SUBJECT: RESPONSE TO NRC LTR DTD 05/02/78... FORWARDING RESPONSE TO QUESTIONS 1, 2, 3C,  
5, 6, 7, 8, & 10 CONCERNING CONTINUED CYCLE 1 OPERATION WITHOUT BURNABLE  
POISON ROD ASSEMBLIES... NOTARIZED 06/02/78.

PLANT NAME: CRYSTAL RIVER #3

Subject: Crystal River Unit #3  
Docket No. 50-302  
Operating License #DPR-72

Figure 1  
CRYSTAL RIVER III CYCLE 1  
254 EFPD

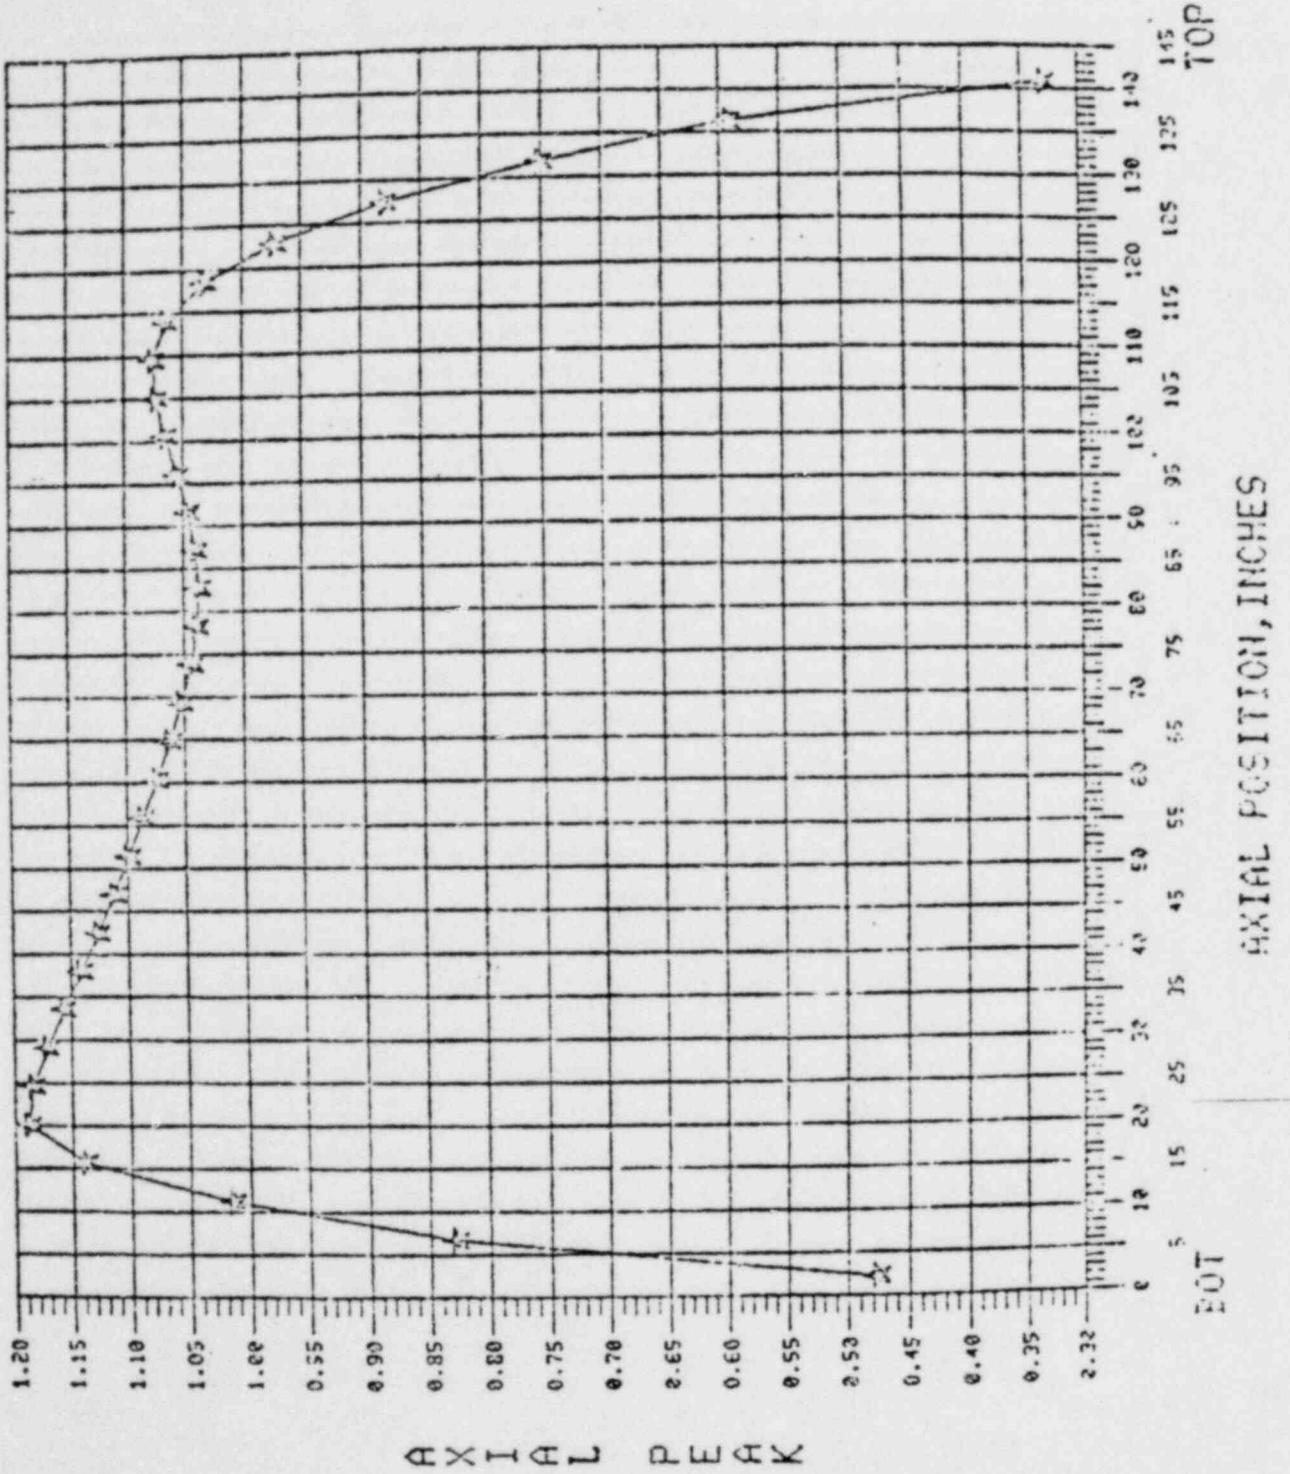
Question 3c- Provide a safety analysis for operation with the burnable poison removed. This analysis should address the effects on axial peaking factors, "flyspeck" analyses and axial imbalance limits. Give quantitative information on the axially-dependent depletion of burnable poison.

The effect of BPRAs removal on the axial power distribution is shown in Figures 1 and 2. The removal of BPRAs causes a shift in the overall distribution, however the magnitude of the axial peak is relatively unchanged. A complete power peaking analysis for the remainder of cycle 1, with BPRAs removed, was performed for C. 3. The study included normal operating conditions, abnormal core conditions including mispositioned control rods and APSRs, and variable xenon conditions. The resultant power peaks were compared to the thermal limits, DNBR and centerline fuel melt, by means of "flyspeck" curves. The original axial imbalance limits for the Reactor Protection System were determined to be conservative for the remainder of cycle 1 with BPRAs removed. The axial imbalance limits for LOCA power peaking have been altered for the remainder of cycle 1 as shown in Reference 3. The LOCA peaking limits are a function of axial position. The removal of BPRAs alters the overall axial distribution such that the peaking behavior at various axial positions is different from the original design.
